# UNITED STATES PATENT AND TRADEMARK OFFICE

APPLICATION NO.	FILING DATE	FIRST NAMED INVENTOR	ATTORNEY DOCKET NO.	CONFIRMATION NO.
09/347,845	09/30/1999	YI YANG	243/079	4401

# Office Action Summary

## DETAILED ACTION

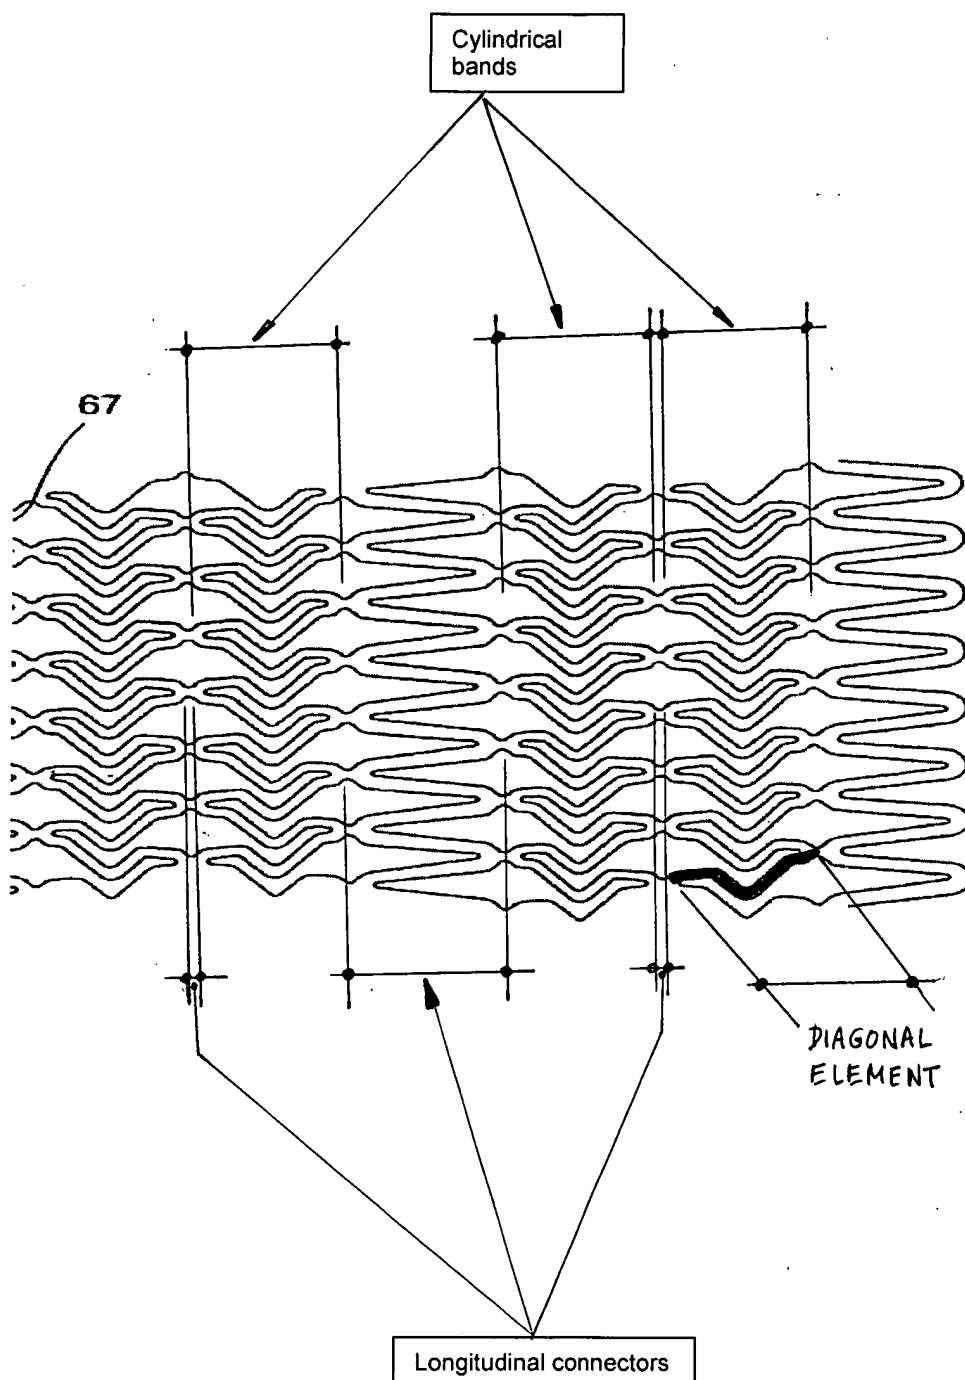
As to claims 1, 3-4, 8-11, and 24-25, VON OEPEN (Fig. 8 as reproduced and shown on **page 5** of this paper and see column 1, lines 36-39, VON OEPEN) discloses a **non-sinusoidal** zigzag pattern tubular stent (60) expandable from a contracted condition for easy introduction of the stent into a body lumen (a blood vessel) to an enlarged condition for supporting and keeping the body lumen (the blood vessel) open. Inherently, the stent is biased from a contracted condition either by a balloon or by a self-expanding property of the stent material towards an enlarged condition (as recited in claims 4, 24-25) to support the body lumen. The stent comprises:

- **A central portion consists essentially of a series of cylindrical bands, each band comprises a generally non-sinusoidal zigzag pattern of diagonal elements having generally arcuate shapes, arbitrarily assigned either a clockwise or counter clockwise orientation. Notice that the central portion consists essentially**

of a series of cylindrical bands because the central portion includes a majority of cylindrical bands .

- A plurality of straight and short or long connectors (I-shaped labeled as elements 66, 67) extending substantially parallel to the longitudinal axis of the stent. Notice that in a contracted configuration during deployment of the stent, connectors 66, 67 are squeezed closed one to each other and connectors 66, 67 are substantially parallel to the longitudinal axis of the stent.

- The short longitudinal connectors have a longitudinal dimension substantially smaller than a longitudinal dimension of the diagonal elements (as recited in claim 9). The diagonal elements comprise 1<sup>st</sup> and 2<sup>nd</sup> generally straight portions having 1<sup>st</sup> ends connected to preceding and succeeding diagonal elements and 2<sup>nd</sup> ends being connected together (as recited in claim 10).

- The diagonal elements of each cylindrical band are out of phase with any adjacent cylindrical band (as recited in claim 11).

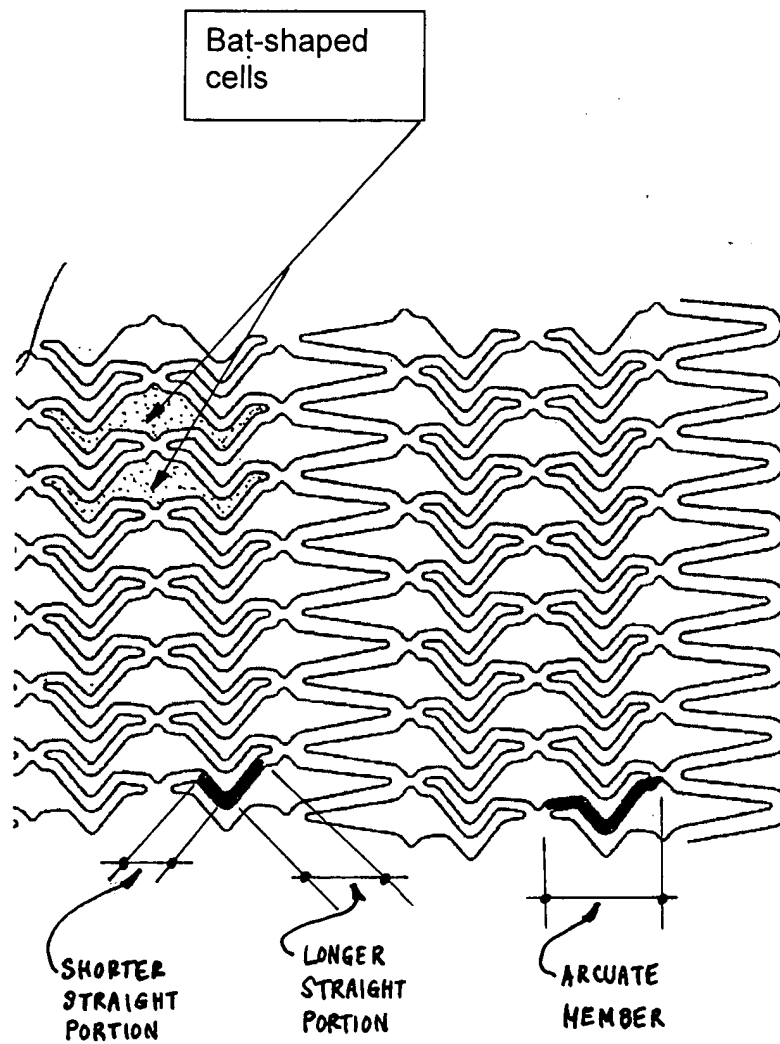
As to claims 12-15 and 17-22, VON OEPEN (Fig. 8 as reproduced and shown on **page 6** of this paper; see column 1, lines 36-39, VON OEPEN) discloses a tubular stent (60) comprising:

- A central portion consist essentially of a plurality of bat-shaped cells formed from **non-sinusoidal** cylindrical bands each cell having a head region, a tail region and opposing curved wing regions. The central portion consists essentially of a plurality of bat-shaped cells because there are a majority of bat-shaped cells in the central portion.
- A plurality of **straight short and long** connectors (I-shaped) extending substantially parallel to a longitudinal axis (as recited in claims 12 and 15) and

connecting each of the adjacent cells. Notice that in a contracted configuration during deployment of the stent along a blood vessel, connectors 66, 67 are squeezed closed one to each other and connectors 66, 67 are substantially parallel to the longitudinal axis of the stent.

- The head and tail regions are aligned about the circumference of the stent, the wing regions have a generally V-shaped extending longitudinally away from the head and tail regions (as recited in claim 13).

- The cells are arranged sequentially about the circumference, thereby defining a cylindrical band (as recited in claim 14).
- The wing regions are defined by 1<sup>st</sup> and 2<sup>nd</sup> arcuate members, the 1<sup>st</sup> and 2<sup>nd</sup> arcuate members comprising a pair of generally straight portions connected to one another by a curved portion, and the curved portion defines an apex of the "V" shape curved wing regions, the apices all pointing substantially in a single direction (as recited in claims 17-18).

- The head regions and tail regions are defined by longitudinal connectors (I-shaped connectors), one of the straight portions of each of the first and second arcuate members is substantially shorter than the other generally straight portion of the respective arcuate member, and the longitudinal connectors define the tail region also define the head region of an adjacent cell (as recited in claims 19-21).

- The connectors comprise a longitudinal connector (V-shaped connector) extending between a wing region of a first cell and a wing region of an adjacent cell (as recited in claim 22).
